| APPLICATION NO. | FILING DATE | FIRST NAMED INVENTOR | ATTORNEY DOCKET NO. | CONFIRMATION NO. |
|-----------------|-------------|----------------------|---------------------|------------------|
| 09/766,749 | 01/22/2001 | Conal O'Neill | | 1254 |

Office Action Summary

O'NEILL, CONAL

Final Rejection

FIG. 3

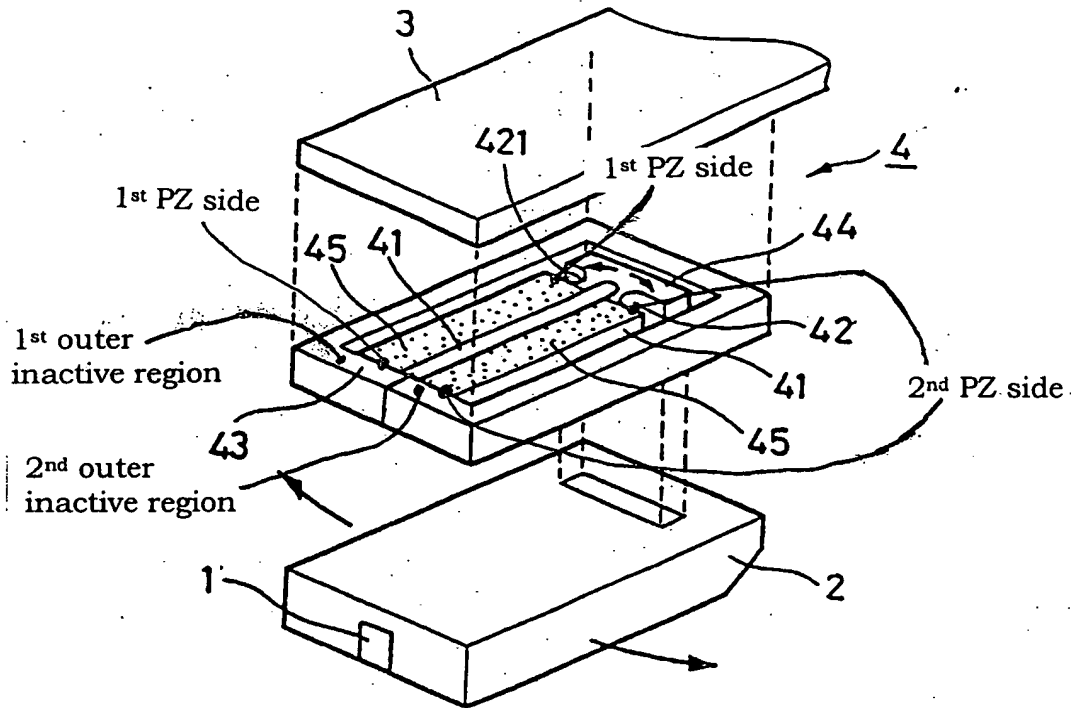
With regard to claims 1-3 and 8-10, Soeno et al shows a disc drive actuation system for precisely positioning a read/write head over a selected track of a rotatable disc (Figs. 18, 19 and 32), the system including: A) a flexure (means) 31 (Column 27, line 41), B) a slider (means) 2 (Column 13, line 44), C) a read/write head 1 firmly attached to the slider, D) a first drive unit (means) 5 (Fig. 32, column 1, line 55) for pivoting the flexure to position the read/write head (means) approximately over the selected track, which is a voice coil motor, E) a microactuator 4 (Figs. 18 and 3) including: 1) an inner inactive region 44, 2) a first outer inactive region (See attached Fig. 3 with added numerals in next page) a second outer inactive region (See attached Fig. 3), 4) a first piezoelectric section (left of 45) sandwiched between the first outer inactive region and the inner inactive region, 5) a second piezoelectric section (right of

45) sandwiched between the second outer inactive region and the inner inactive region, wherein the inner inactive region is firmly attached to the slider (means) and both of the outer inactive regions being firmly attached to the flexure (means) (Column 6, lines 35-37), 6) an inherent electrical circuit for energizing the first and the second piezoelectric sections to cause them to expand and contract in order to precisely position the read/write head (means) over the selected track (Column 34,, lines 44-57), the circuit and the piezoelectric sections being configured such that the first piezoelectric section expands when the second piezoelectric section contracts and the first piezoelectric section contracts when the second piezoelectric section expands, which is shown in Fig. 3, wherein the above mentioned action causes the slider on 44 to rotate as shown in Fig. 3.

With regard to claims 23, 24, and 25; Soeno et al further shows the first piezoelectric section includes two first piezoelectric sides, wherein both of the first piezoelectric sides are opposite to each other (See attached Fig. 3), and wherein the second piezoelectric section includes two second piezoelectric sides (See attached Fig.

3), wherein both of the second piezoelectric sides are opposite to each other, wherein one of the two first piezoelectric sides is rigidly attached to the first outer inactive region and wherein the other of the two first piezoelectric sides is rigidly attached to the inner inactive region, and wherein one of the two second piezoelectric sides is rigidly attached to the second outer inactive region and wherein the other of the two second piezoelectric sides is rigidly attached to the inner inactive region.

- Applicant asserts that using “sandwiched” to replace the term “mounted” in claims 1 and 8 would overcome the rejection.
- Examiner found that the terms “first outer inactive region” and “second outer inactive region” were not carefully defined in claims 1 and 8. A modification on defining the regions in the prior art as shown in the attached Fig. 3 would make the prior art read the amended claims 1 and 8 well.
- Rejection on claims 1 and 8 maintains.

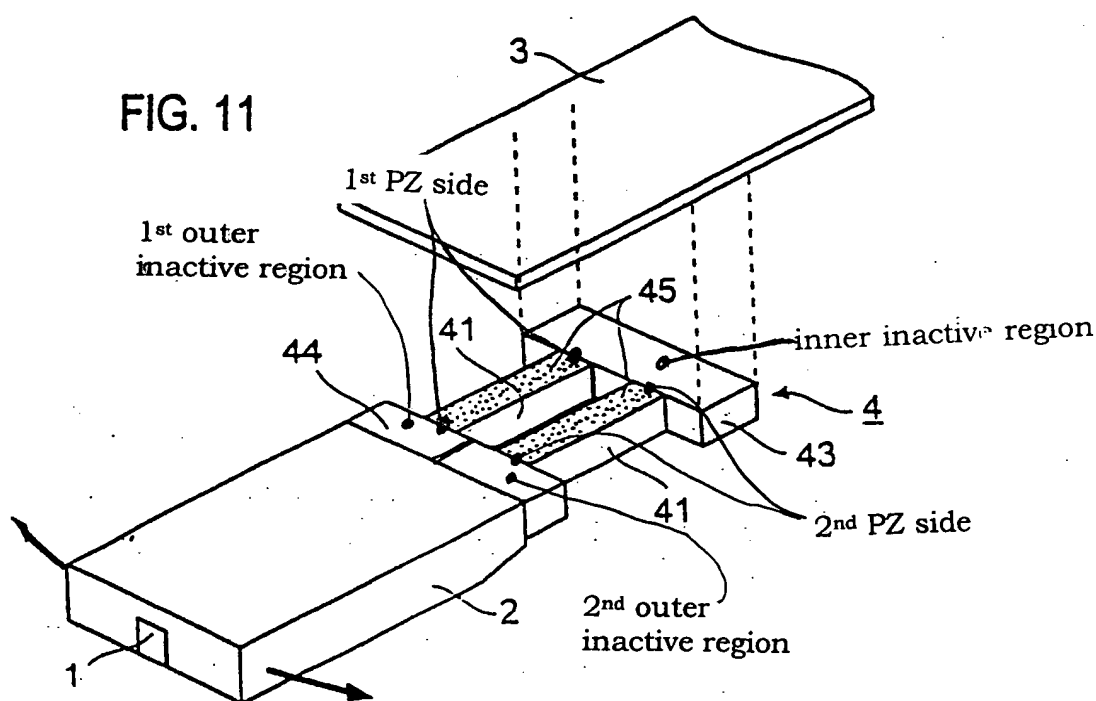
With regard to claims 4/1, 11/8, and 15; Soeno et al shows a disc drive actuation system for precisely positioning a read/write head over a selected track of a rotatable disc (Figs. 18, 19 and 32), the system including: A) a flexure (means) 31 (Column 27, line 41), B) a slider (means) 2 (Column 13, line 44), C) a read/write head 1 firmly attached to the slider, D) a first drive unit (means) 5 (Fig. 32, column 1, line 55) for pivoting the flexure to position the read/write head (means) approximately over the selected track, E) a microactuator 4 (Figs. 18 and 11) including: 1) an inner inactive region 43 (Fig. 11) a first outer inactive region (See attached Fig. 11 with added numerals in next page) a second outer inactive region (See attached Fig. 11),

4) a first piezoelectric section (left of 45) sandwiched between the first outer inactive region and the inner inactive region, 5) a second piezoelectric section (right of 45) sandwiched between the second outer inactive region and the inner inactive region, wherein the inner inactive region is firmly attached to the flexure (means) and both of

the outer inactive regions being firmly attached to the slider (means), 6) an inherent electrical circuit for energizing the first and the second piezoelectric sections to cause them to expand and contract in order to precisely position the read/write head (means) over the selected track (Column 34,, lines 44-57), the circuit and the piezoelectric sections being configured such that the first piezoelectric section expands when the second piezoelectric section contracts and the first piezoelectric section contracts when the second piezoelectric section expands, which is shown in Fig. 11, wherein the above mentioned action causes the slider on 44 to rotate as shown in Fig. 11.

With regard to claim 15, Soeno et al further shows the slide is independently supported by the microactuator (Fig. 11).
